**Niagara Region Wind Farm
Renewable Energy Approval
Amendment
Modification Report**

File No. 160950269
October 5 2015

NIAGARA REGON WIND FARM - RENEWABLE ENERGY APPROVAL AMENDMENT MODIFICATION REPORT

Figure No.
1

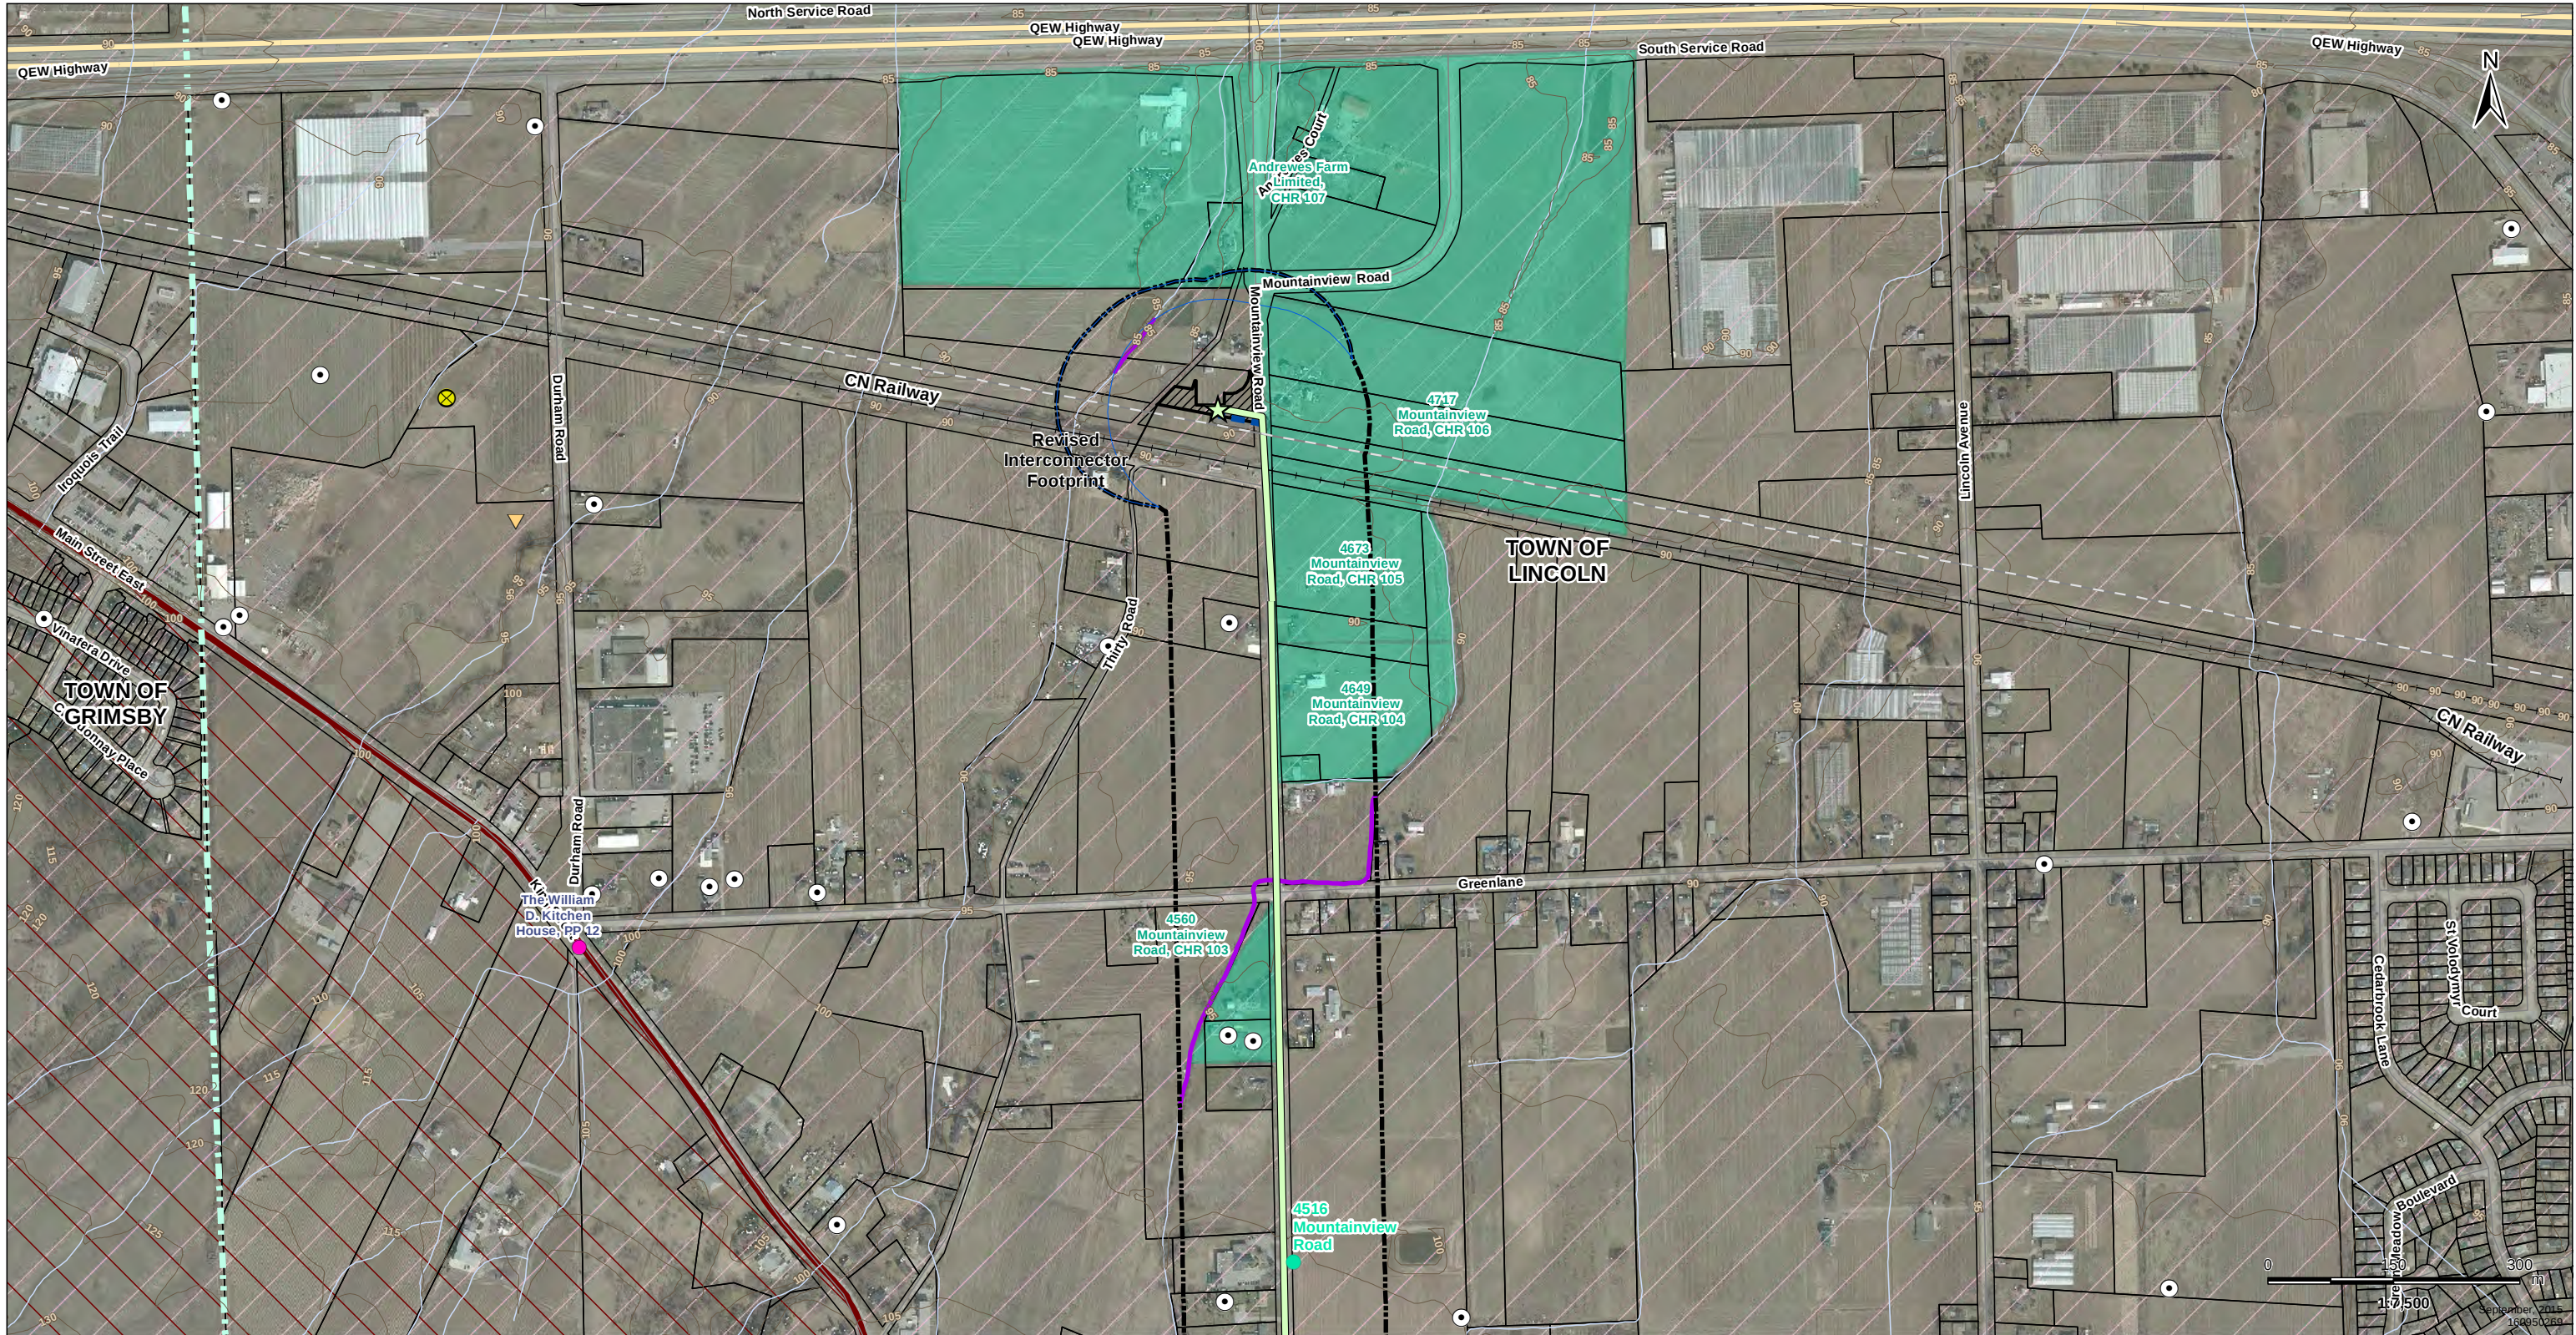
REA Reports & Studies	Change (Yes/No)	Figure No.	Discussion of change / Justification for 'no' change
REA REPORTS			
Project Description Report	Yes	1, 2.1, 2.20, 2.28, 2.31, 2.35, 2.39, 2.41, 2.43, 2.48, 2.54	Figures to be updated to display the revised Footprint of Interconnect Station, Alternate Access Road from T11 to T12 to T41, Footprint of North Substation, and revised Access Road Entrances, Appendix A (Modification A, B, C, D, and G). Section 1.1: (a) update text to a rated capacity ranging from 2.9MW to 3.0MW, 90 MVA base rating for north transformer and 69 MVA for the south transformer. Section 3.1: (a) amend text to remove the use of ENERCON E82, (b) update text to a rated capacity ranging from 2.9MW to 3.0MW, (c) Table 3.1 – amend text to remove turbine specifications for E82 and remove 135 m hub height, include new turbine model specifications for the customized ENERCON E101 (2.9MW), and (d) Table 3.2 – update turbine hub height and remove turbine model E82. Section 3.2.4: (a) update text to 90 MVA base rating for north transformer and 69 MVA for the south transformer, and (b) update locations of the north and south transformer sound barrier.

Construction Plan Report	Yes	1, 2.1, 2.20, 2.28, 2.31, 2.35, 2.39, 2.41, 2.43, 2.48, 2.54	Figures to be updated to display the revised Footprint of Interconnect Station, Alternate Access Road from T11 to T12 to T41, Footprint of North Substation, and revised Access Road Entrances, Appendix A (Modification A, B, C, D, and G). Section 1.1: (a) update text to a rated capacity ranging from 2.9MW to 3.0MW, 90 MVA base rating for north transformer and 69 MVA for the south transformer. Section 2.0: (a) amend text to remove reference to ENERCON E82, (b) Table 2.1 – update text to 90 MVA base rating for north transformer and 69 MVA for the south transformer, (c) update the locations of the north and south transformer sound barrier and (d) update the potential location for junction boxes.
Design & Operations Report	Yes	1, 2.1, 2.20, 2.28, 2.31, 2.35, 2.39, 2.41, 2.43, 2.48, 2.54	Figures to be updated to display the revised Footprint of Interconnect Station, Alternate Access Road from T11 to T12 to T41, Footprint of North Substation, and revised Access Road Entrances, Appendix A (Modification A, B, C, D, and G). Section 1.1: (a) update text to a rated capacity ranging from 2.9MW to 3.0MW, 90 MVA base rating for north transformer and 69 MVA for the south transformer. Section 2.1: (a) update turbine hub height, and (b) amend text to remove reference to ENERCON E82. Section 3.1: (a) Table 3.1 update turbine specifications to include the customized

**Records Review -
Natural Features
Figure 2.1
Revised**

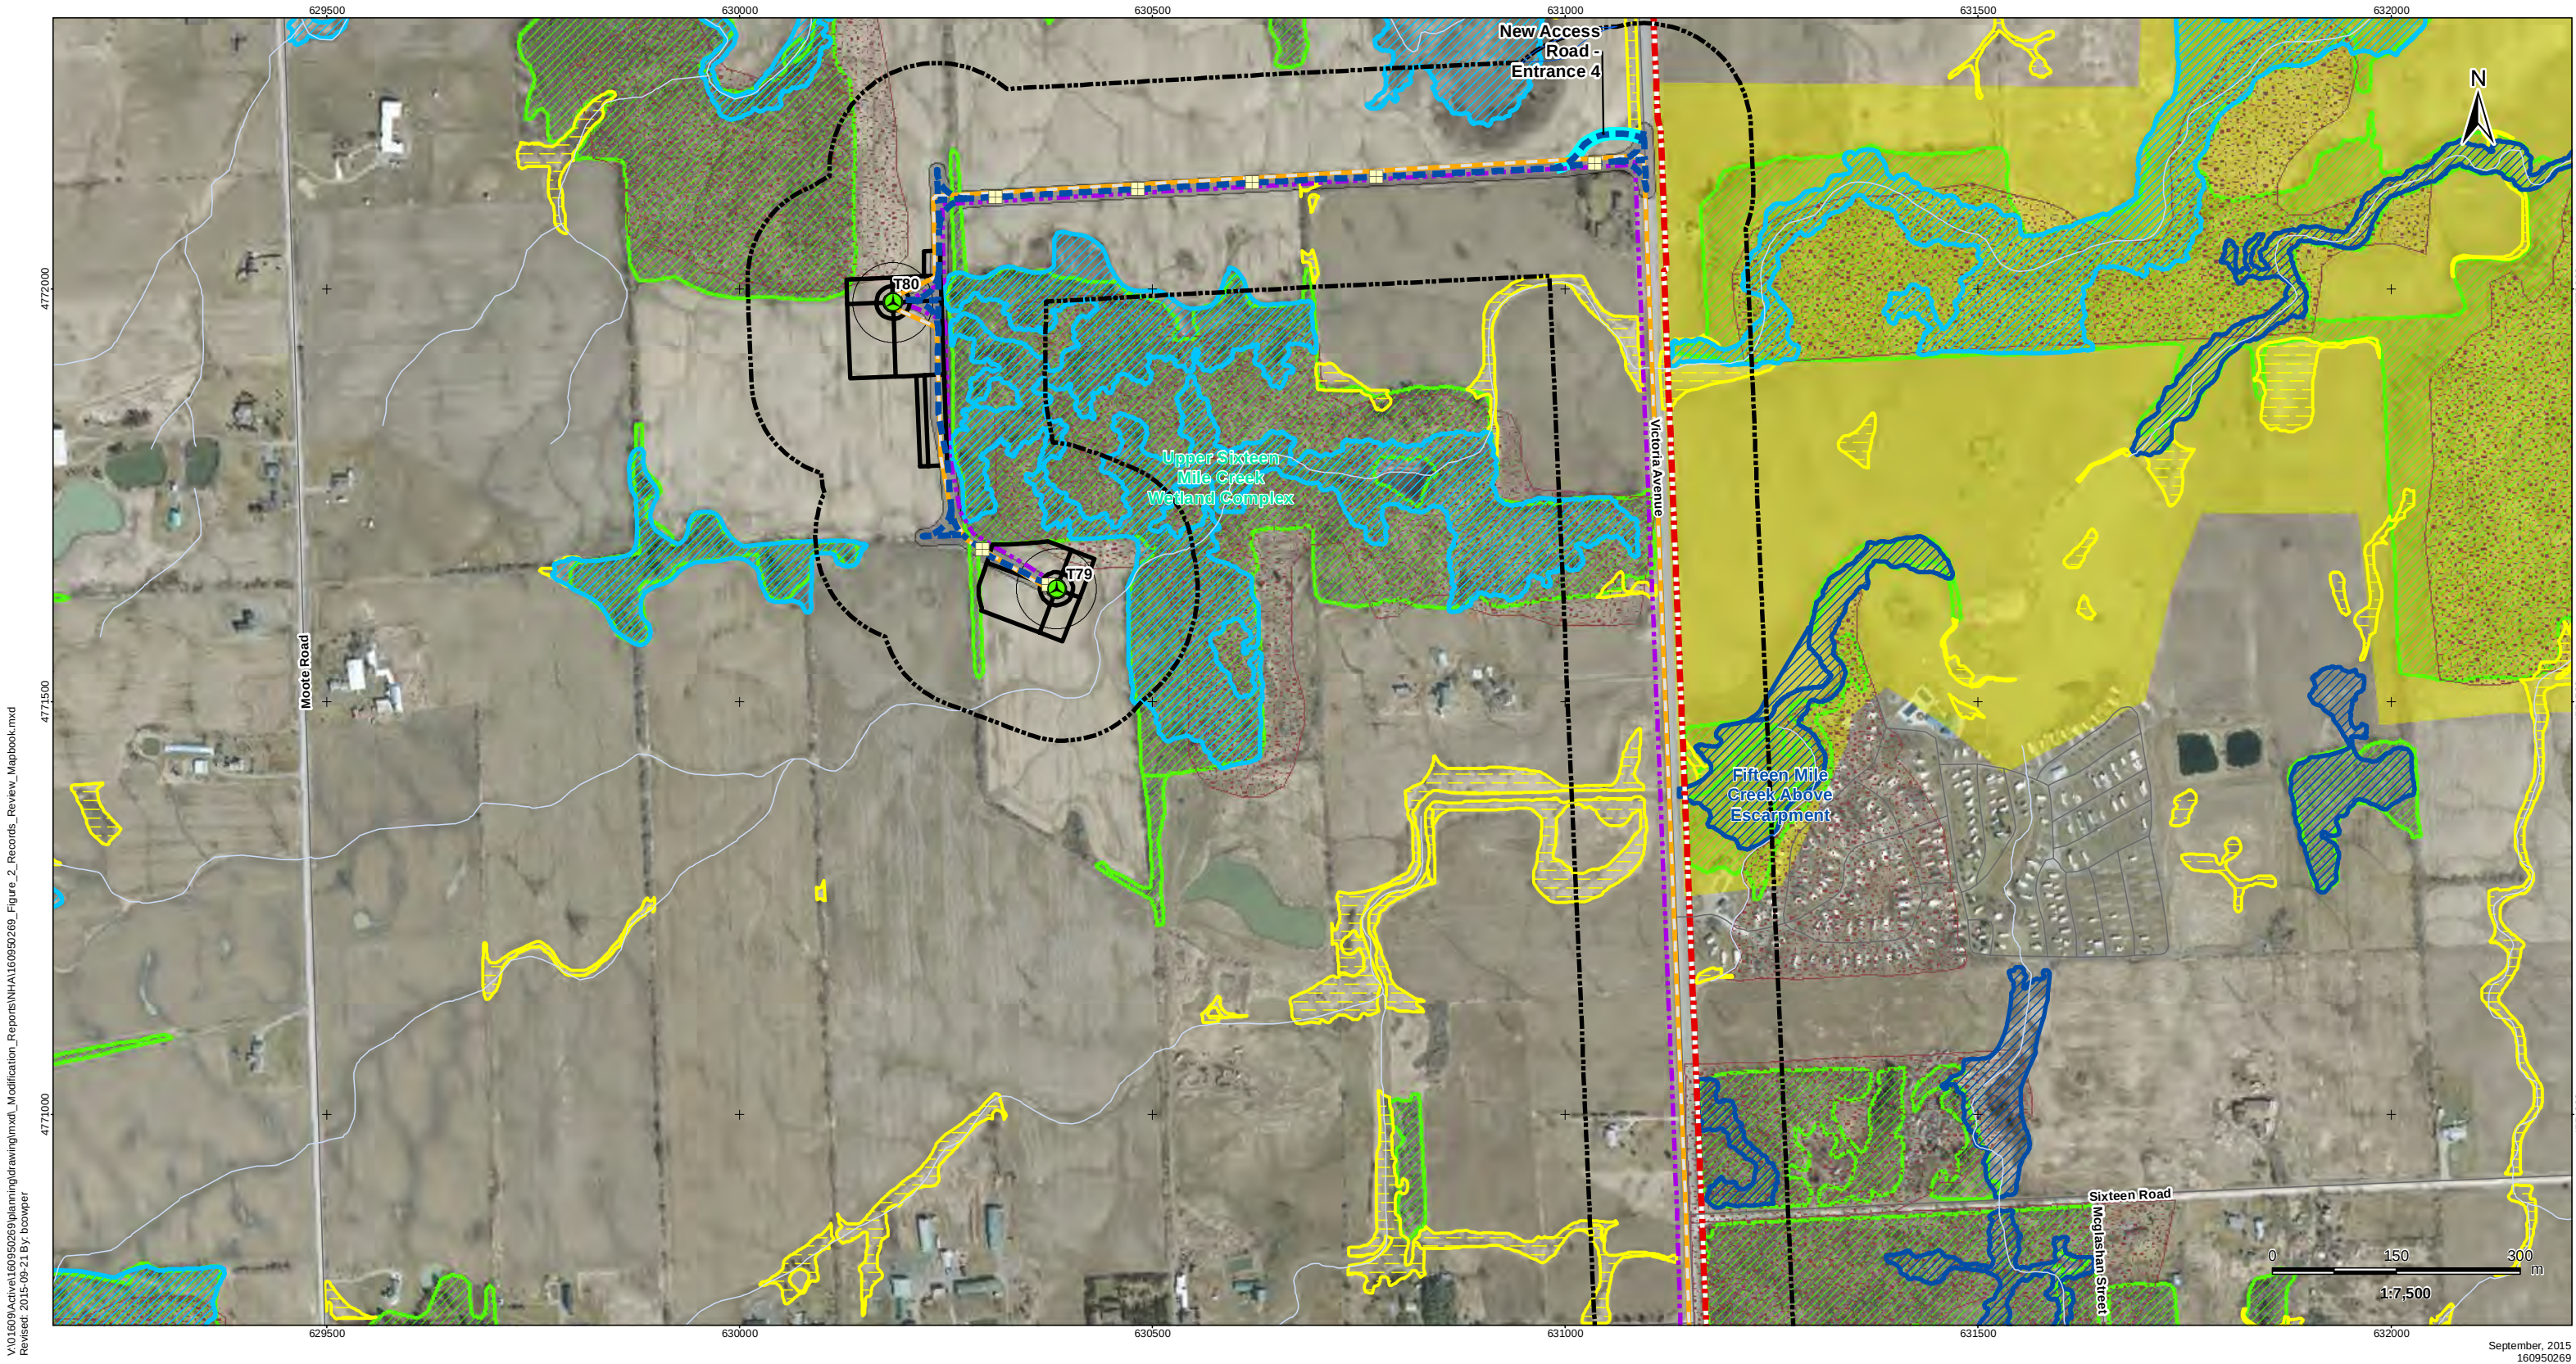
ADDITIONAL REPORTS			
Natural Heritage Assessment Report	Yes	1, 2.1, 2.20, 2.28, 2.31, 2.35, 2.39, 2.41, 2.43, 2.48, 2.54; 3.1, 3.20, 3.28, 3.35, 3.39, 3.41, 3.43, 3.48, 3.54; 4.1, 4.20, 4.28, 4.35, 4.39, 4.41, 4.43, 4.48, 4.54; 5.1, 5.20, 5.28, 5.35, 5.39, 5.41, 5.43, 5.48, 5.54; 6.1, 6.20, 6.28, 6.35, 6.39, 6.41, 6.43, 6.48, 6.54; 7.1, 7.20, 7.28, 7.35, 7.39, 7.41, 7.43, 7.48, 7.54	Figures to be updated to display the revised Footprint of Interconnect Station, Alternate Access Road from T11 to T12 to T41, Footprint of North Substation, and revised Access Road Entrances, Appendix A (Modification A, B, C, D, and G). Executive Summary: a) update text to a rated capacity ranging from 2.9MW to 3.0MW, 90 MVA base rating for north transformer and 69 MVA for the south transformer. Section 1.1: (a) update text to a rated capacity ranging from 2.9MW to 3.0MW, 90 MVA base rating for north transformer and 69 MVA for the south transformer. Approved NHA/EIS was completed assuming a rotor diameter of 101 m at all turbine locations, including those previously approved as E82 turbines. No change in turbine location required. See Appendix B for a copy of the Natural Heritage Assessment Addendum.
